Project/File: **The Boardwalk / GC19-0030 / DSRFY2019-25**
 The applicant is requesting design review approval of a mixed-use development.

Lead Agency: Garden City

Site address: 406 E. 40th Street, 507 E. 41st Street, 510 E. 41st Street

Staff Approval: April 6, 2020

SITE PLAN

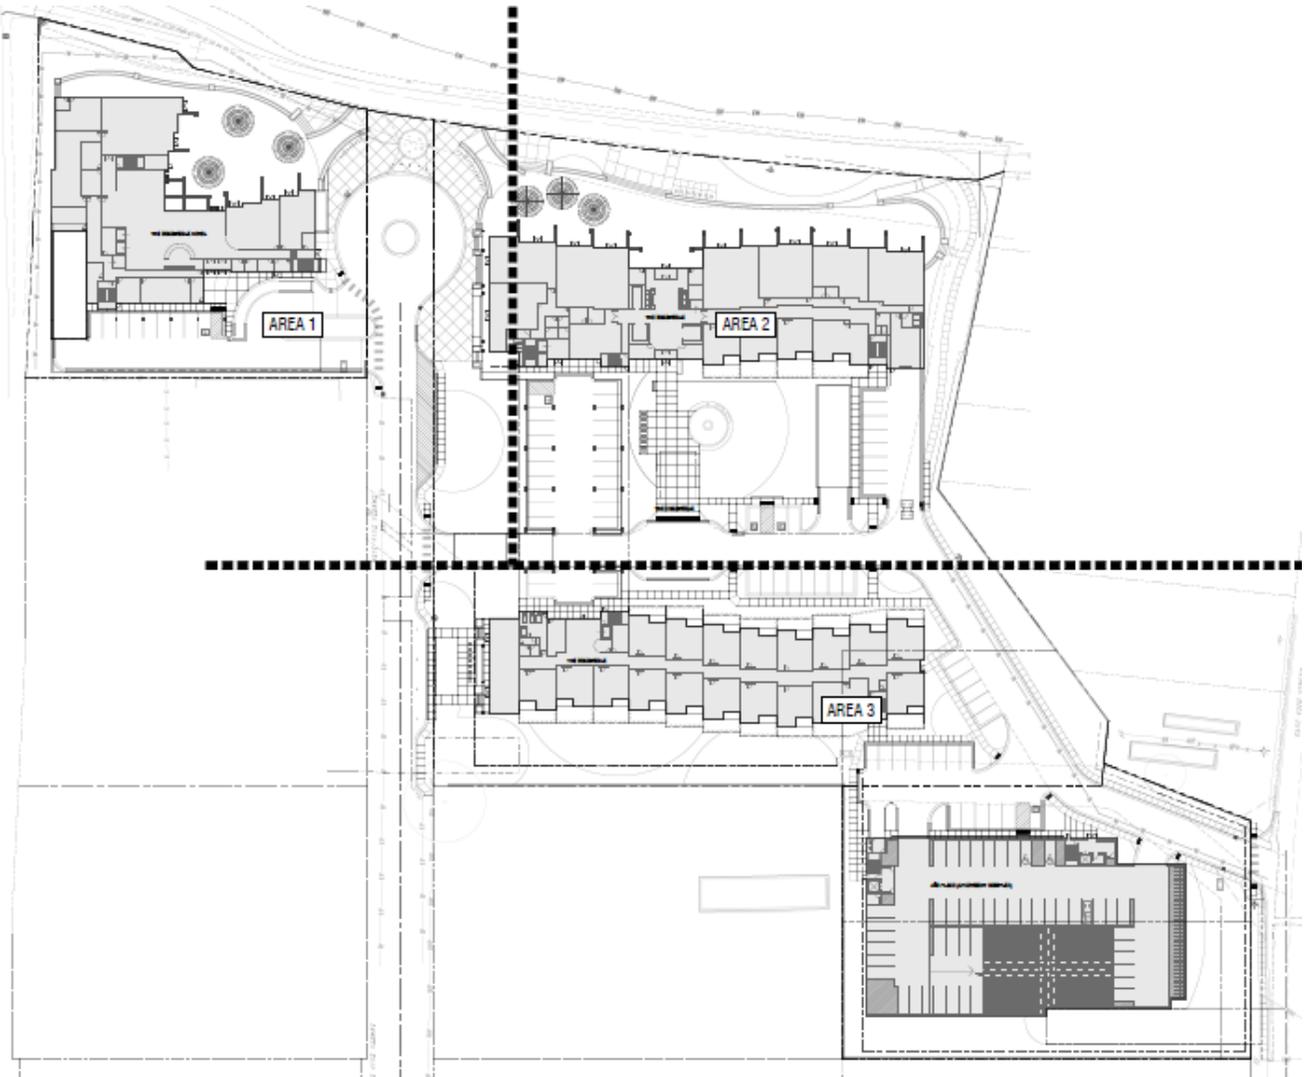
- d. **Staff Comments/Recommendations:** The applicant's proposal to construct 41st Street as ½ of a 33-foot street section does not meet District policy which requires a 36-foot street section with vertical curb, gutter and 5-foot wide attached concrete sidewalk. A permanent right-of-way easement shall be provided if public sidewalks are placed outside of the dedicated right-of-way.

The applicant's proposal to terminate 41st Street in a cul-de-sac meets District policy. However, the applicant's proposed 48-foot radius does not meet District policy. Staff recommends a modification of policy as the proposed design accommodates all ACHD maintenance vehicles. The applicant should be required to provide written fire department approval for the reduced width cul-de-sac or construct a cul-de-sac with a 55-foot radius, consistent with District policy. Right-of-way should be dedicated extending 7-feet past the back edge of curb to ensure a minimum 5-foot wide concrete sidewalk around the cul-de-sac. The center landscape island should be dedicated as right-of-way owned by ACHD. A license agreement is required for landscaping within the proposed center landscape island.

The proposed 41st Street cul-de-sac terminates 40-feet south of the existing right-of-way line. District policy requires the right-of-way to be vacated or improved. Staff recommends the applicant vacate the right-of-way north of 41st Street. The vacation of right-of-way is a separate process with its own application and approval process. The vacation should be completed prior to plan approval.

The applicant should be required to provide a minimum of 12-feet from centerline to back-of-curb at the proposed bulb-out/driveway locations. Detached sidewalk should be constructed at bulb-out locations to avoid meandering sidewalks.

The applicant's proposal to construct a 54-foot wide driveway on 41st Street does not meet District Driveway width policy, which restricts driveways on commercial roadways to a maximum width of 40-feet. However, staff recommends a modification of policy to approve the driveway as proposed. This is due to the grade change entering/exiting the site, and the added pedestrian visibility.

A 4-foot wide detached sidewalk is proposed to be constructed across the 54-foot wide driveway on the east side of 41st Street. District policy discourages meandering sidewalk and requires 5-foot wide concrete sidewalk. The applicant should be required to redesign the driveway to eliminate the meandering sidewalk.

The applicant's proposed driveways on the west side of 41st Street will be separated by a 15.5-foot wide landscape median, located outside the right-of-way, creating a 60-foot wide crosswalk. The proposed crosswalk curves to match the design of the cul-de-sac at the terminus of 41st Street (illustrated to the right). The proposed 60-foot wide curved cross walk does not meet ADA specifications and should be redesigned to be ADA compliant.

3. Construct 41st Street as ½ of a 36-foot wide commercial street section with vertical curb, gutter and 5-foot wide concrete sidewalk. Provide a permanent right-of-way easement if public sidewalks are placed outside of the dedicated right-of-way.

4. Terminate 41st Street in a cul-de-sac with a center landscape island, as proposed. Provide written fire department approval for the reduced width cul-de-sac or construct a cul-de-sac with a 55-foot radius. Dedicate right-of-way extending 7-feet past the back edge of curb, providing for a minimum 5-foot wide attached concrete sidewalk. A license agreement is required for landscaping within the proposed island.

5. Vacate or improve the existing right-of-way for 41st Street north of the proposed cul-de-sac. The vacation is a separate process with its own application and approval. Complete the vacation prior to plan approval.

- A 50-foot long bulb out located immediately south of the cul-de-sac.
7. Provide a minimum of 12-feet from centerline to back-of-curb at the proposed bulb-out/driveway locations.

8. Construct detached sidewalk at bulb-out locations to avoid meandering sidewalks.
9. If required by Garden City sign the east side of 41st Street between the northern driveway and the cul-de-sac as a loading zone. Painted pavement markings are prohibited.

14. Redesign the proposed 60-foot wide curved crosswalk for the driveways on the west side of 41st Street to be ADA compliant.
15. Construct a 20-foot wide emergency access only driveway on the north side of the 41st Street cul-de-sac to provide access to the greenbelt.
